RE: Data Adequacy, Supplement A  
Ivanpah Solar Electric Generating System (07-AFC-5)

*Supplement A*

**In Response to Data Adequacy Review**

**Ivanpah Solar Electric  
Generating System  
(Ivanpah SEGS)**

FIGURE TSE-1a

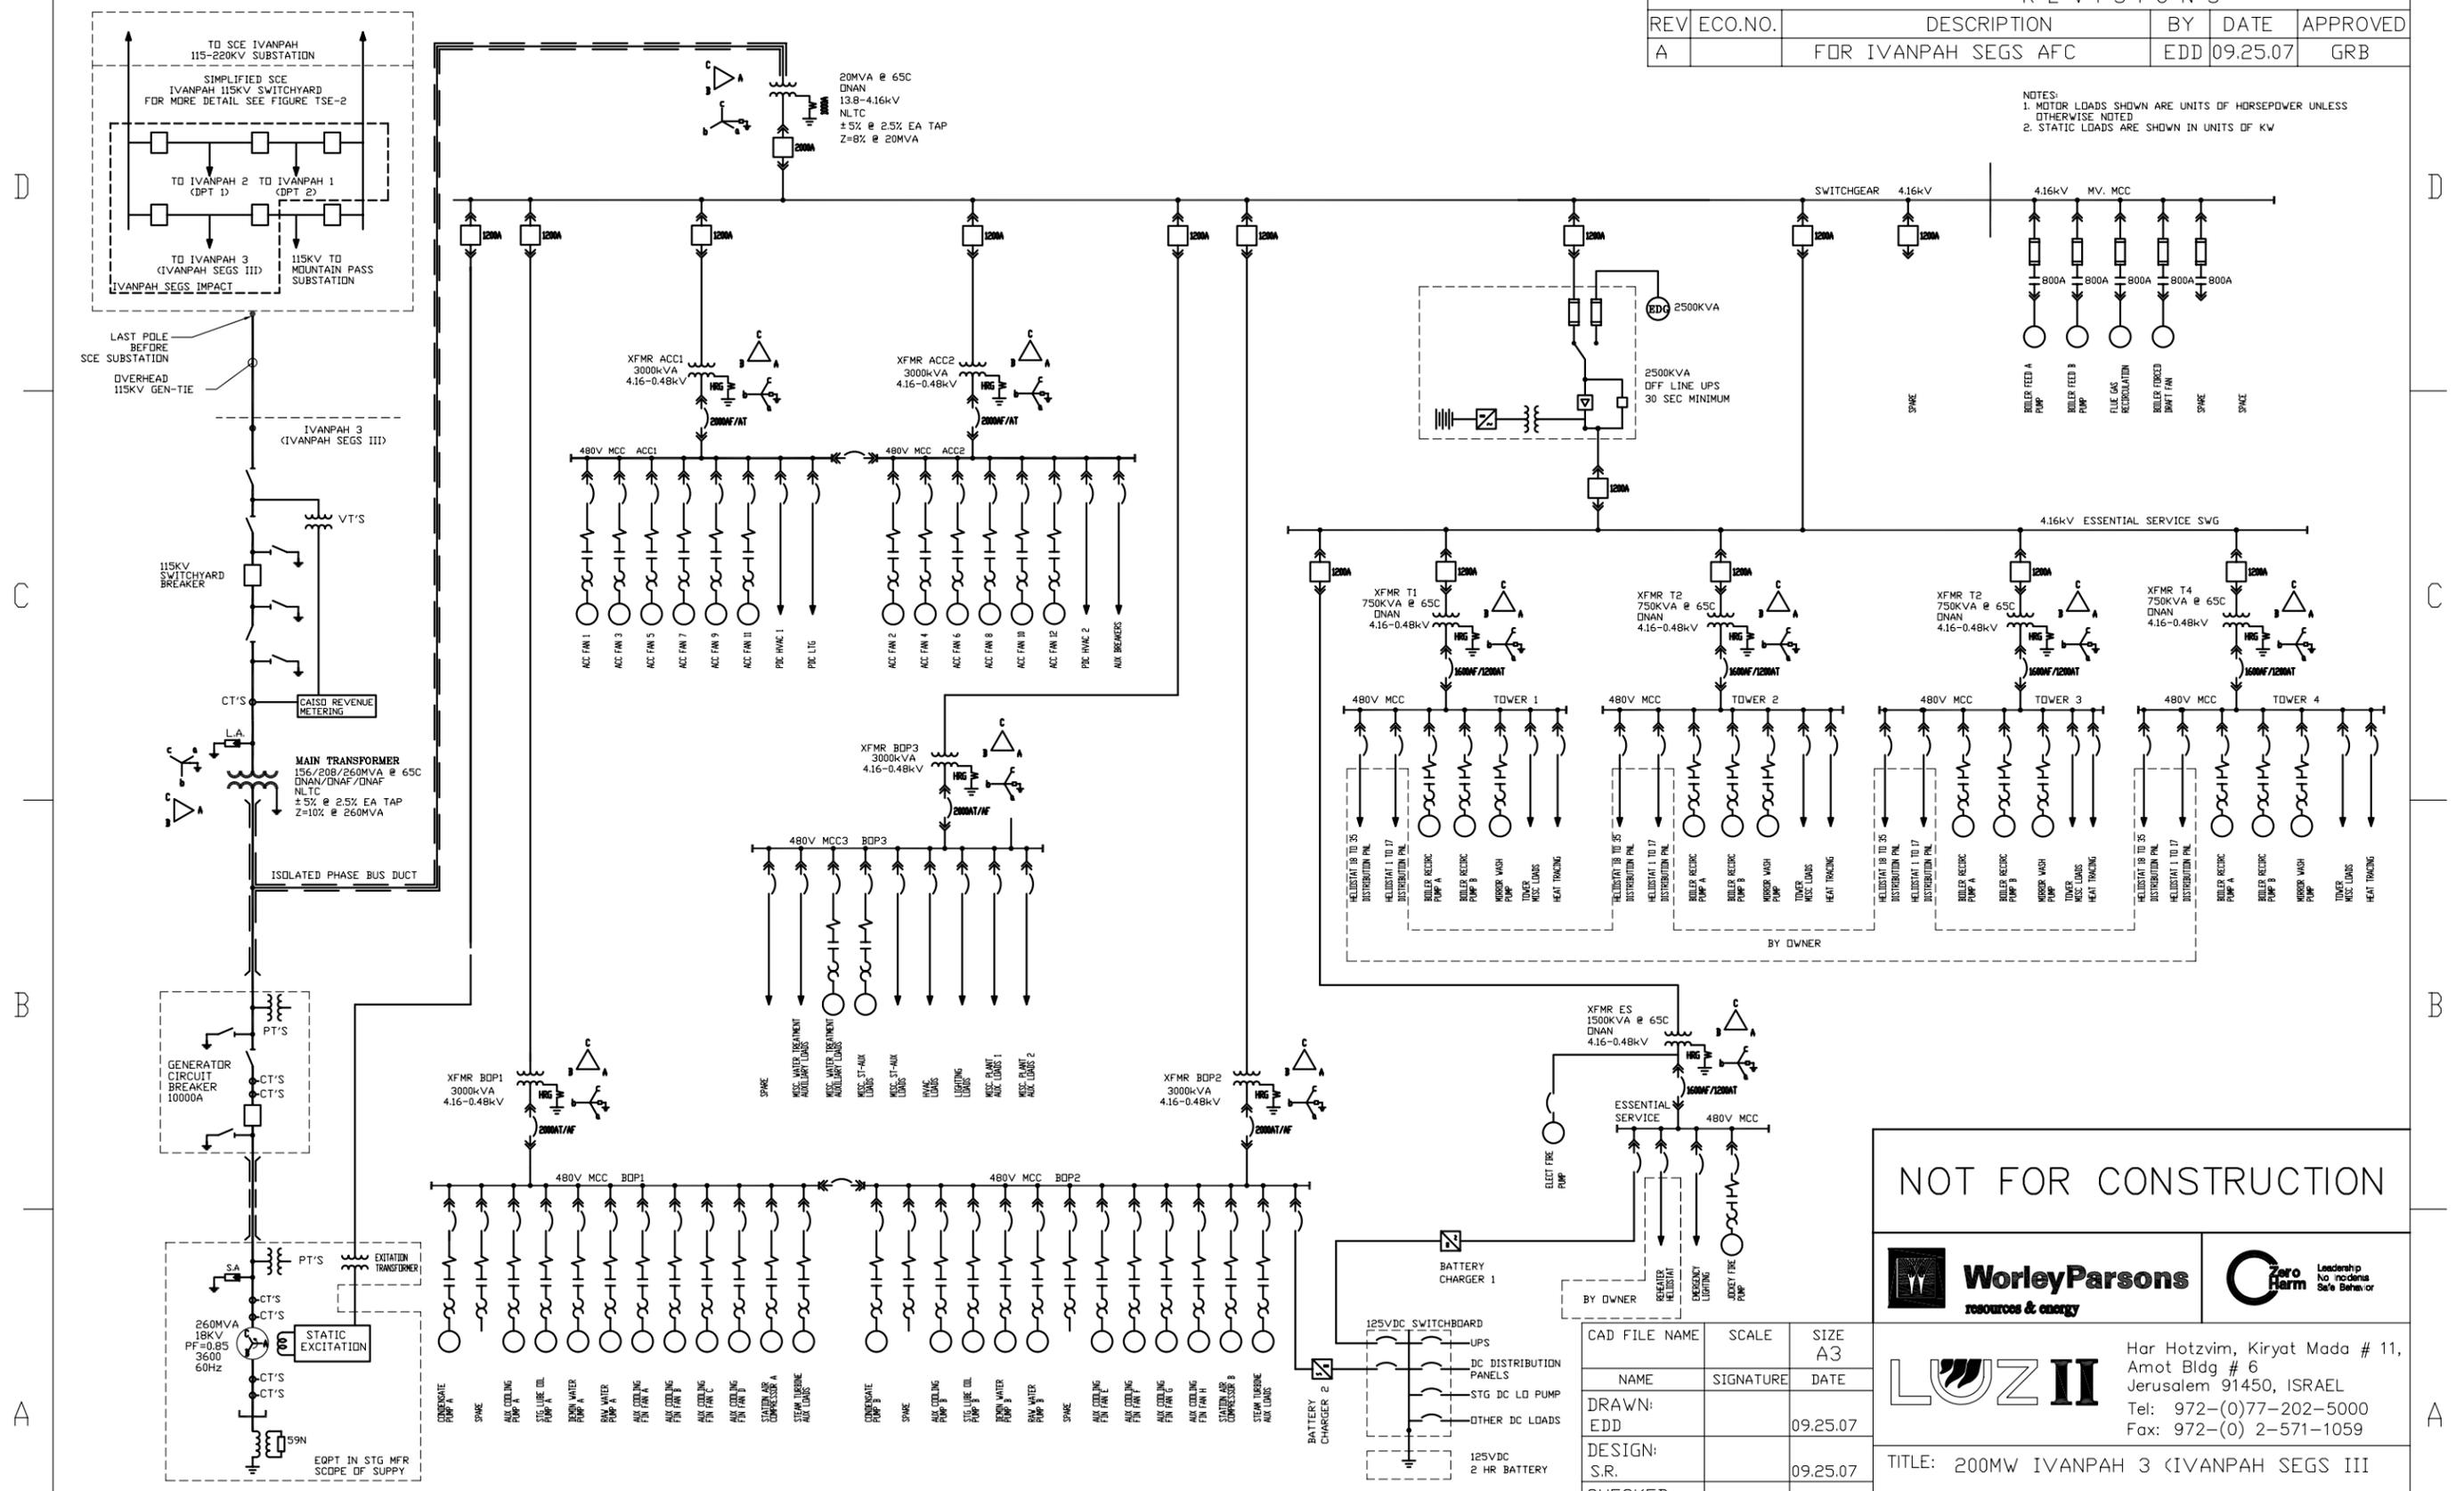
*a. Provide a complete electrical one-line diagram (or resubmit Figures 3.1-1 and 2.2-3b) of Ivanpah Solar Electric Generating System (Ivanpah SEGS) 1, 2 and 3 switchyards showing all equipment for generator interconnection with the switchyard including any bus duct connectors or cables, 4.16-kV switchgear & breakers on the low side (19 kV), generator step-up transformers, short overhead line or conductors with its configuration, buses, breakers and disconnect switches on the 115 kV side and their respective ratings.*

**Response** – One-line diagrams of the 100 MW plant (Figure TSE-1a) and the 200-MW plant (Figure TSE-1b) are attached.
